LICENSEE: Toledo Edison Company
FACILITY: Davis-Besse Nuclear Power Station, Unit No. 1
SUBJECT: SUMMARY OF MEETING - NOVEMBER 26, 1985 ON SFAS MODIFICATIONS

SAFETY FEATURES ACTUATION SYSTEM
CHANNEL INDEPENDENCE

MEETING AGENDA: Safety Features Actuation System
Channel Independence

OPTION: PHYSICALLY SEPARATE COMMONS BETWEEN CHANNELS

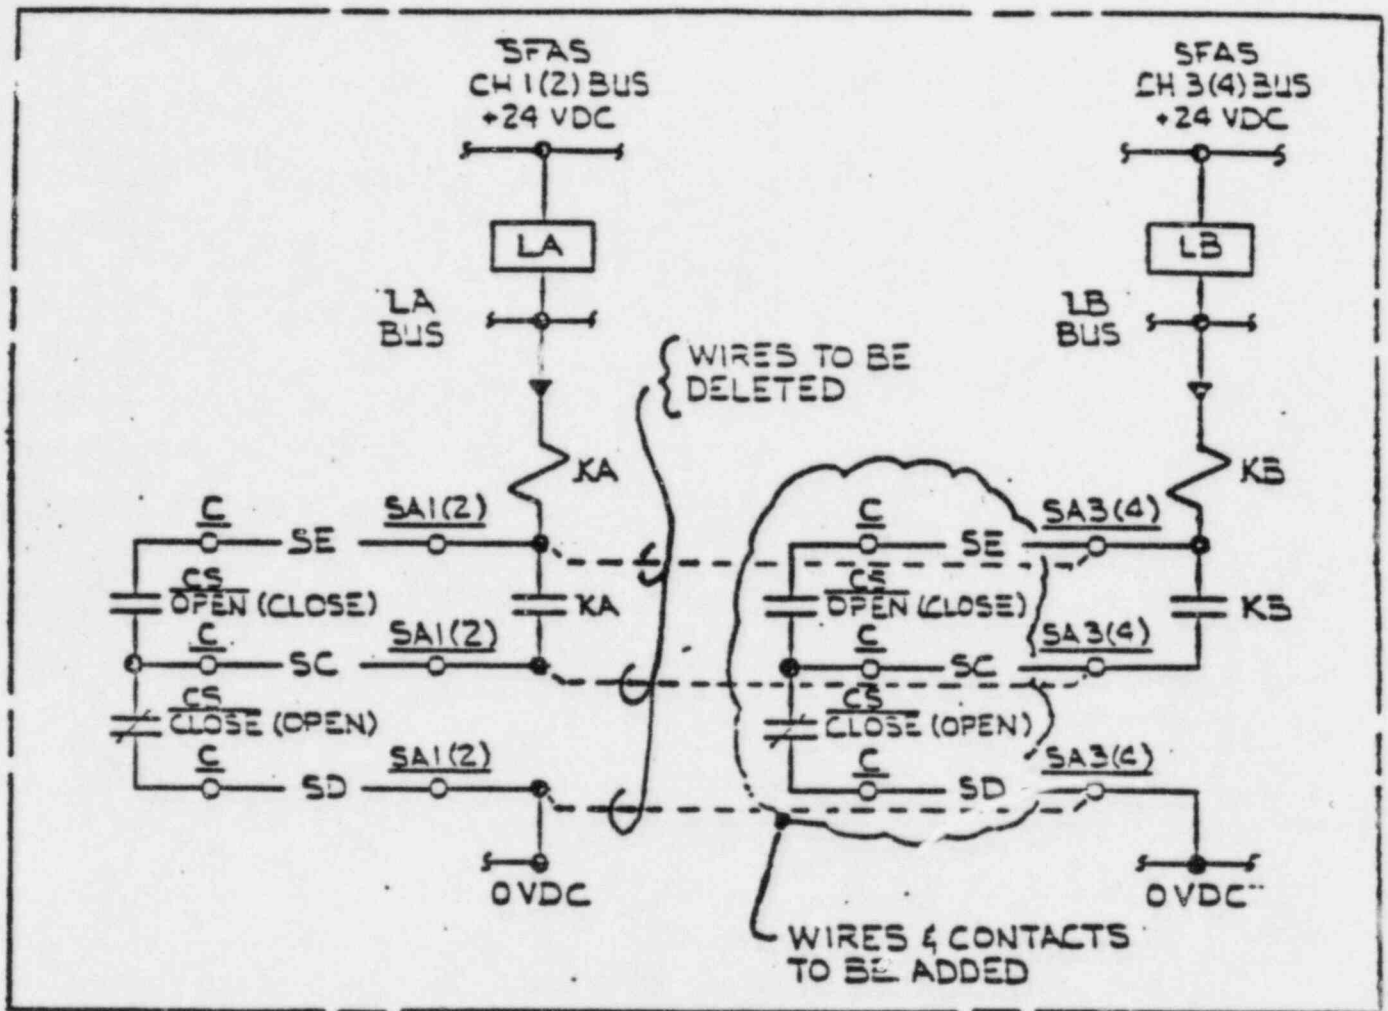
- ASSURES THAT SFAS IS IMMUNE TO A SINGLE FAILURE WHICH COULD AFFECT TWO SENSOR CHANNELS.
- DOES NOT MAKE SFAS MORE SUSCEPTIBLE TO SPURIOUS TRIPS OR EQUIPMENT DAMAGE.

- EXTENSIVE FIELD WIRING AND HARDWARE REQUIRED.
- CURRENT SYSTEM SPACE LIMITATIONS WOULD NOT ALLOW FOR ADDITIONAL TERMINATIONS REQUIRED.
- SYSTEM RELIABILITY REDUCTION.

(REFLECTS REVISION REQUIRED TO DWG. E-30B, SH. 4)

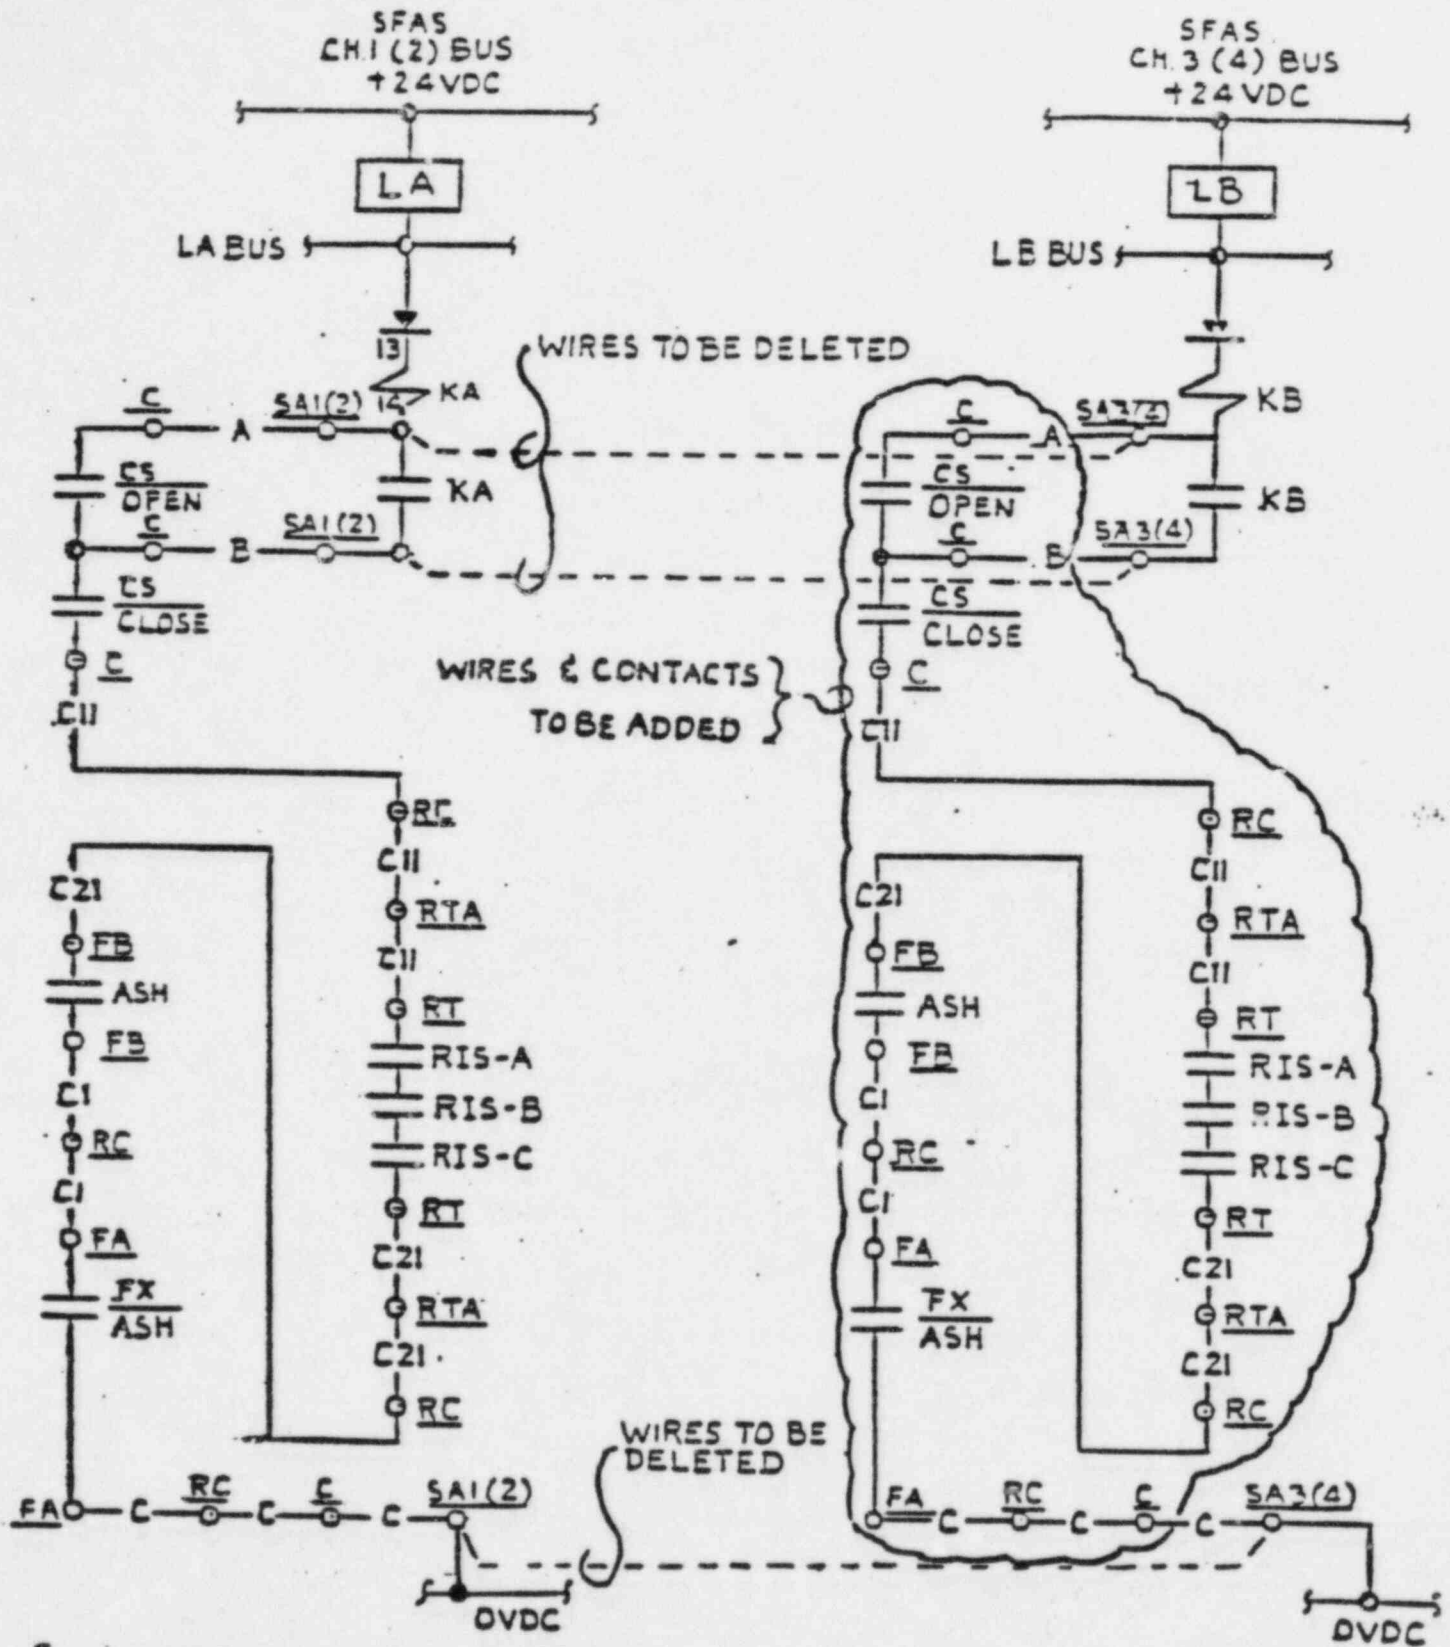
PHYSICALLY SEPARATED COMMONS BETWEEN CHANNELS

OPTION: SEPARATION OF SENSOR CHANNEL COMMONS
(TED PREFERRED OPTION)

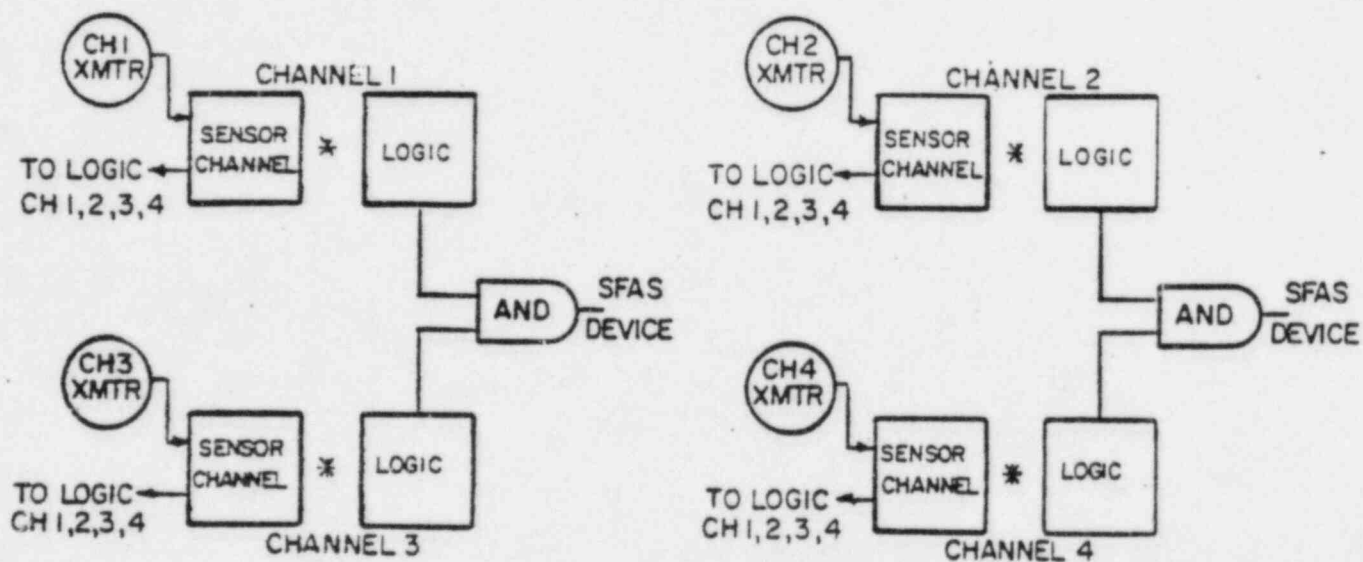
- ASSURES THAT SFAS IS IMMUNE TO A SINGLE FAILURE WHICH COULD AFFECT TWO SENSOR CHANNELS.
- DOES NOT MAKE SFAS MORE SUSCEPTIBLE TO SPURIOUS TRIPS OR EQUIPMENT DAMAGE.
- REQUIRES NO FIELD WIRING CHANGES.

- REQUIRES VERY AMBITIOUS SCHEDULE TO ALLOW INSTALLATION PRIOR TO PLANT RESTART.
